# UNITED STATES PATENT AND TRADEMARK OFFICE

10/525,030

Millind Diwakar Atrey

<b>Office Action Summary</b>	<b>Application No.</b> 10/525,030	<b>Applicant(s)</b> ATREY ET AL.	
	<b>Examiner</b> DNYANESH KASTURE	<b>Art Unit</b> 4147

FIG. 4

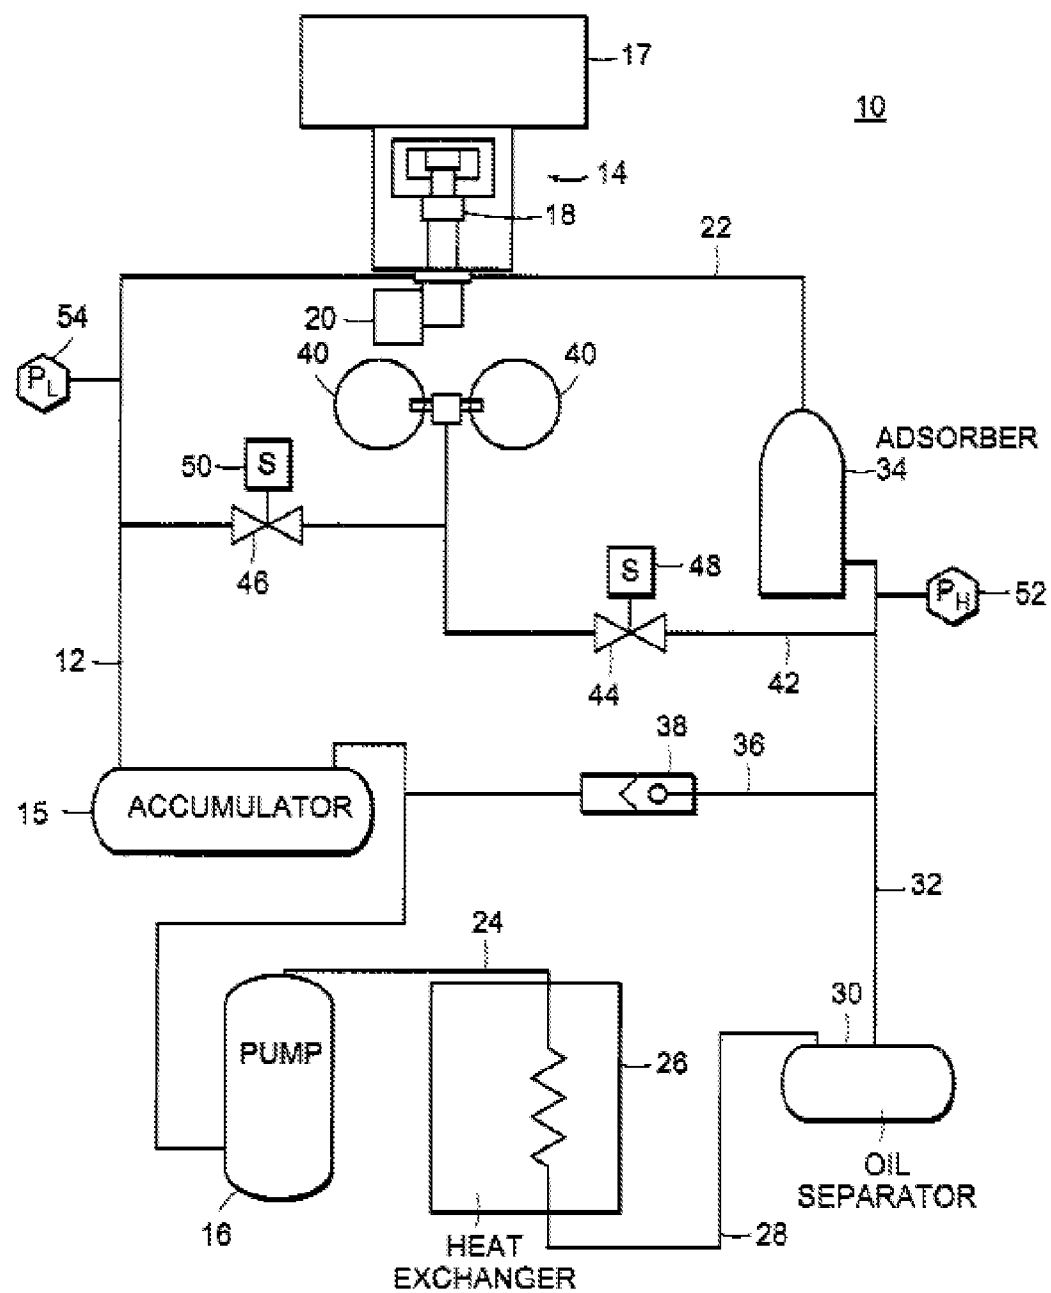
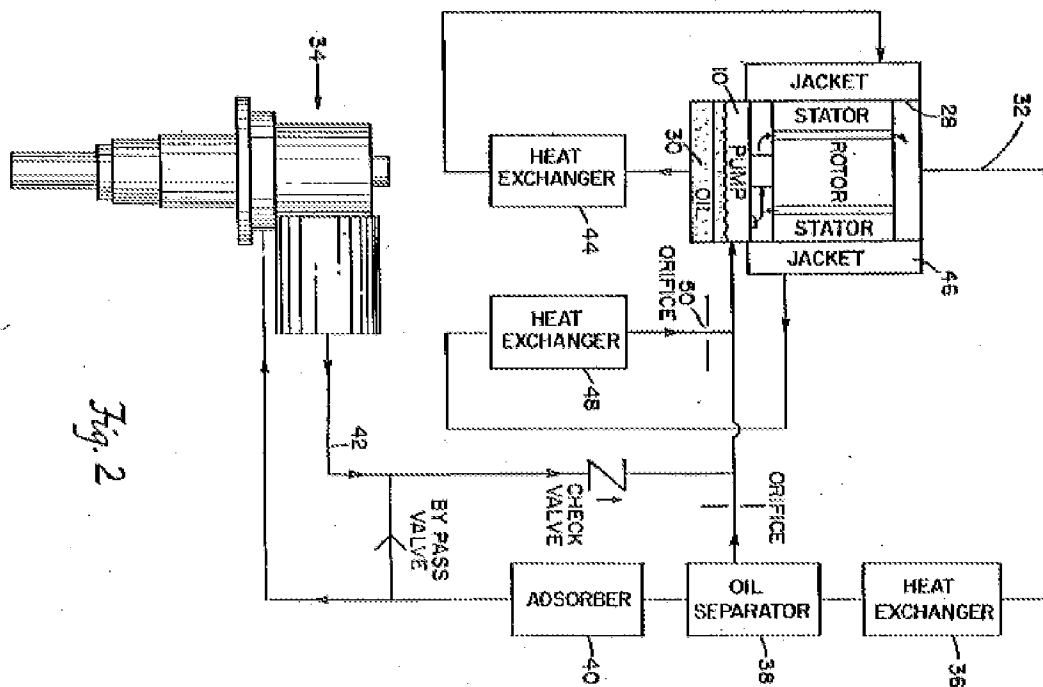
10. In Re claim 1, with reference to Figure 4 above, Morse et al discloses a pumped helium circuit (column 3, lines 25-29) comprising:

- a compressor (16)
- high pressure port which is inherent to the compressor pump outlet
- low pressure port which is inherent to the compressor pump inlet
- supplied equipment (17)
- compressed helium is supplied through line (22) and returns from line (12)
- a pressure relief valve (38) which opens in response to a predetermined pressure differential linking the high and low pressure ports as stated in column 3, lines 55-60: "When the pressure of the helium within the supply line 32 reaches a certain

point beyond the pressure necessary to overcome the bias against the valve, the valve opens to allow helium to flow from the helium supply line to the helium return line 12..”

- With regards to “means for preventing oil carry-over from the compressor to the supplied equipment, characterized in that said means comprises means for preventing oil leaving the low pressure port and traveling towards the supplied equipment” within claim 1, this limitation meets the three prong test per MPEP 2181 and thereby invokes 35 USC 112 6<sup>th</sup> paragraph. The means for preventing oil carry-over from the compressor to the supplied equipment has been disclosed in the specification as an oil trap or an oil adsorber which prevents oil from leaving the low pressure port and travels towards the supplied equipment. Morse et al discloses an accumulator (15) which provides a "Buffer" as stated in column 3, line 31. The accumulator (15) is therefore the corresponding element for an oil trap or oil adsorber.

14. In Re claims 2 and 3, Morse et al discloses an accumulator (15) between the low pressure port of compressor (16) and the supplied equipment (17) as discussed above.

15. In Re claim 4, Morse et al discloses a gas reservoir (40) between the low pressure port of compressor (16) and the supplied equipment (17).

16. In Re claim 5, Morse et al discloses a gas reservoir (40) located near to the accumulator (15). The accumulator (15) is equivalent to an oil adsorber. The gas reservoir (40) and the accumulator/oil adsorber (15) together are located between the low pressure port of the compressor (16) and the supplied equipment (17) in the circuit.

FIG. 2

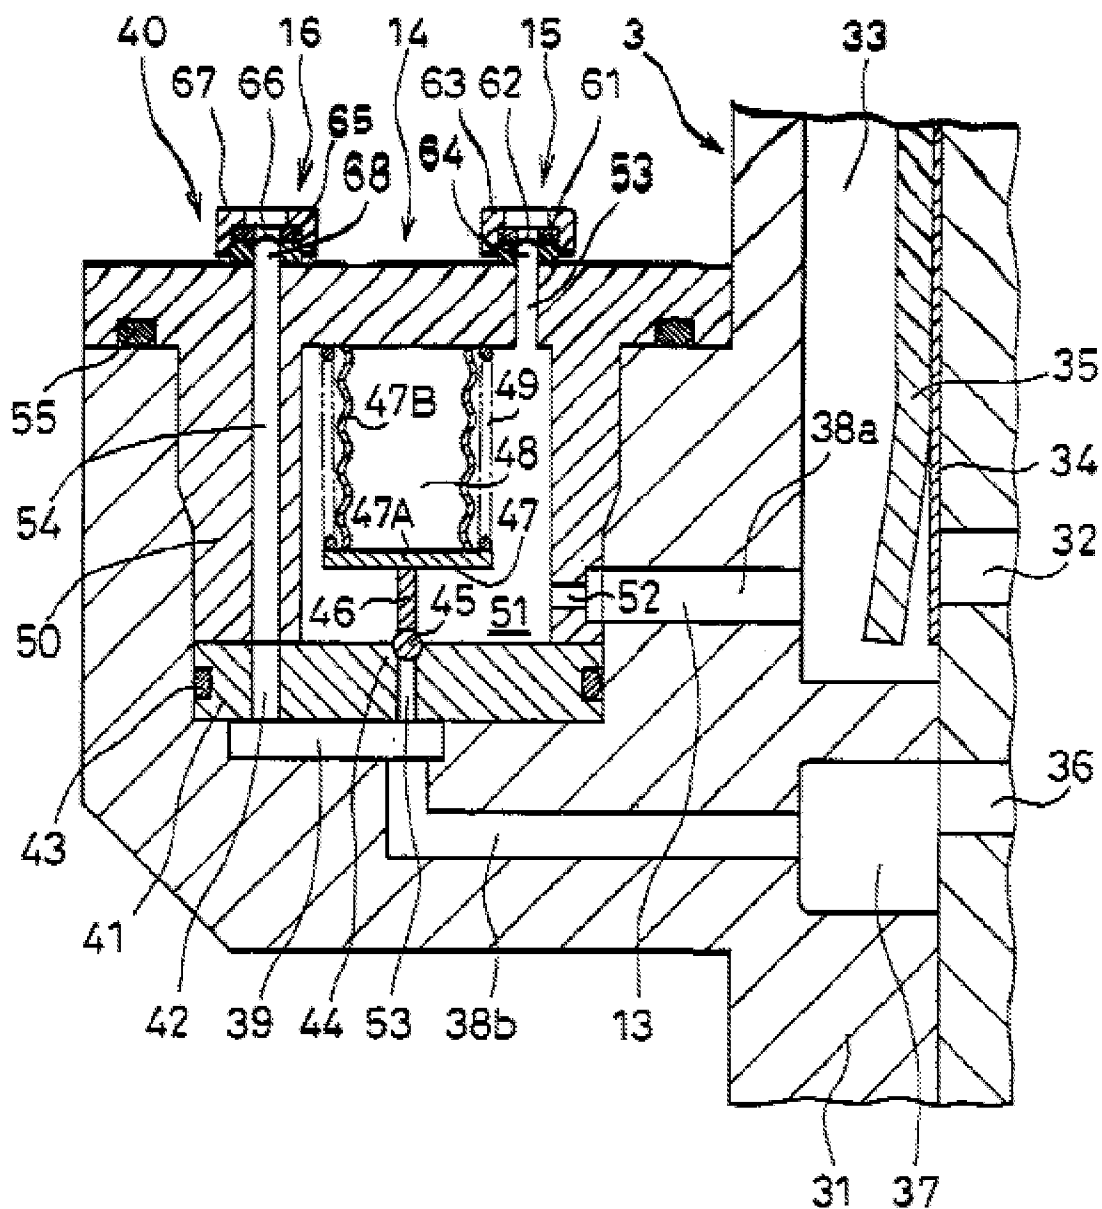
25. Nevertheless, in Figure 2 depicted above, Kanai et al discloses a valve element (45) between the bypass passage (38a) (originating at the high pressure side) and bypass passage (38b) inside the compressor. The valve (45) is operable to return compressed helium from the high pressure port back to the compressor through internal bypass passages (38a) and (38b) in response to a predetermined pressure differential.
